Sheet: /MCU/MCU_POWER_RF/
File: mcu_power.kicad_sch

Sheet: /POWER CONVERSION/
File: power_conv.kicad_sch

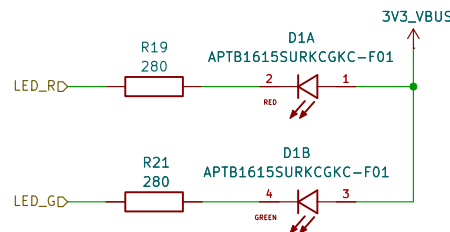
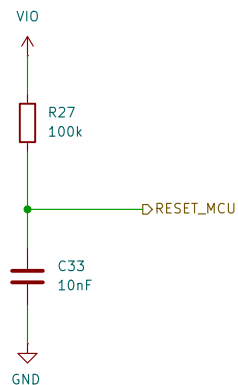
Add reset button?
already implemented in poc_in
poc_out configuratio with sw3.
poc_in is the master of the
reset.

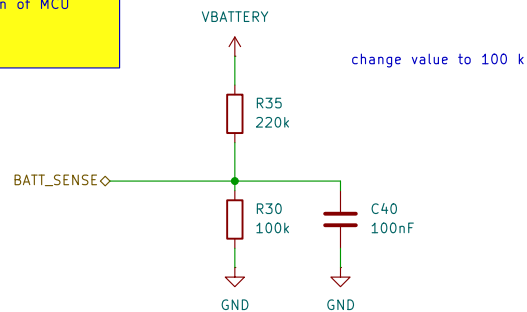
Instead of fuel gauge just add resistor divider to ADC pin of MCU

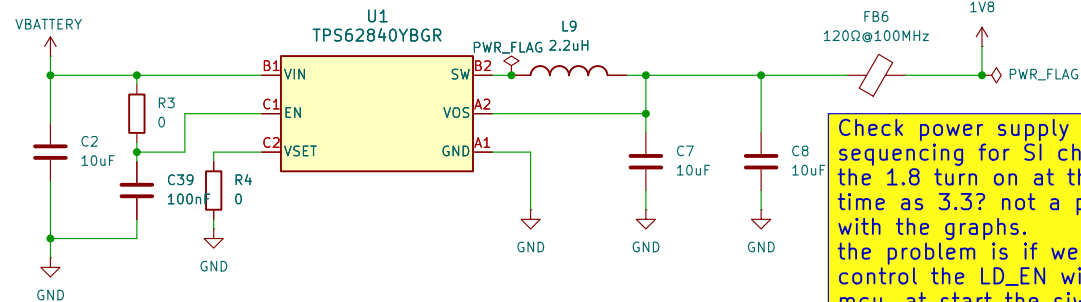
Check power supply sequencing for SI chip: can the 1.8 turn on at the same time as 3.3? not a problem with the graphs.
the problem is if we want to control the LD_EN with the mcu. at start the siwg can't work properly so can't use it. the VBATT of the mcu must be high with the other supply or the first one, but can be later
